# Staff Report to the Western Weber Planning Commission

**Application Request:** Consideration and action on a request for preliminary approval of Stage Coach Estates Subdivision consisting of 116 lots located at approximately 1800 South 3800 W, Ogden.

**File Number:** LVS061323

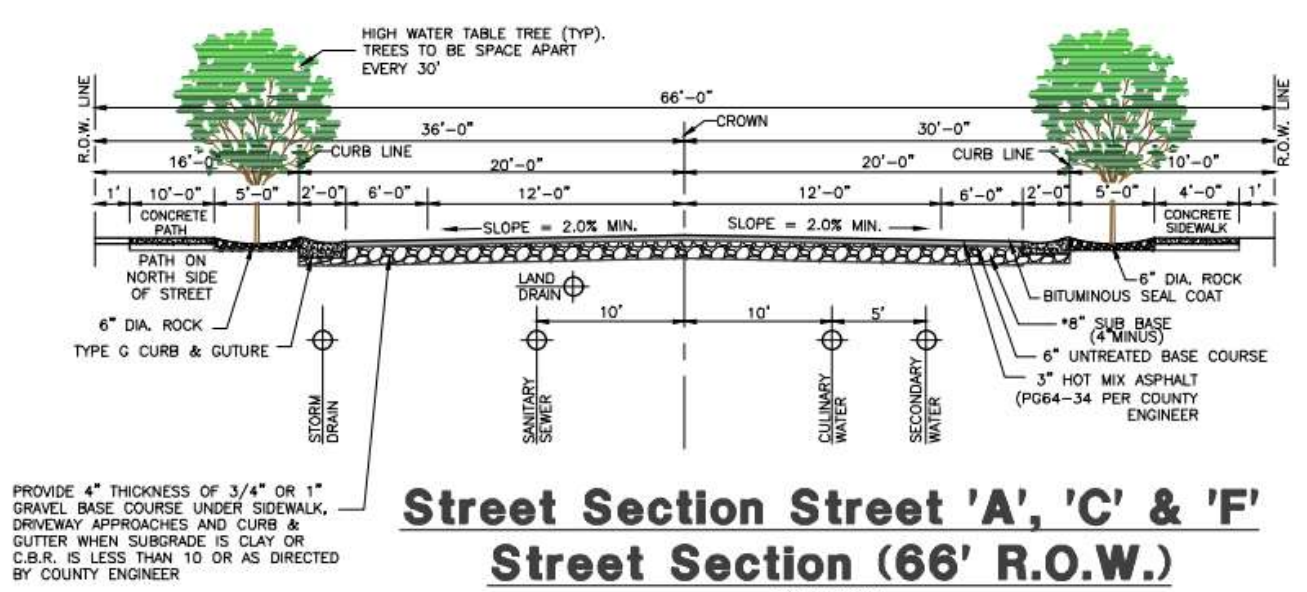
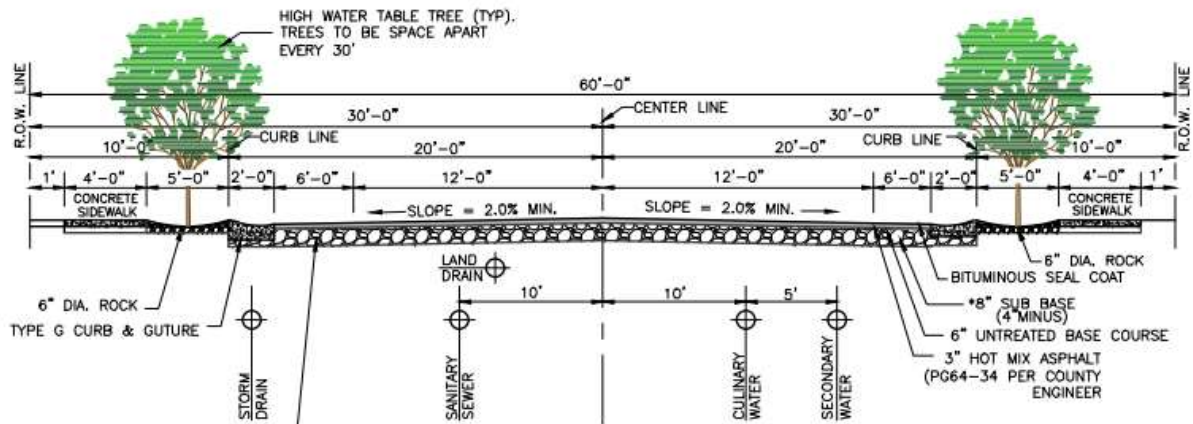
The approved concept plan in the development agreement had 'Street A' as an 80' ROW. In recent discussions, Planning and Engineering don't see a need for a wider north-south roadway that will not continue south beyond 2275 South Street. The County only sees a need for 66' ROW's into this subdivision. The other change from the development agreement is the elimination of the road stub to the north, from 'Street G'. This was seen as an unnecessary vehicular connection, and so is not shown on the preliminary plat, but has been replaced with a 15' wide pathway.
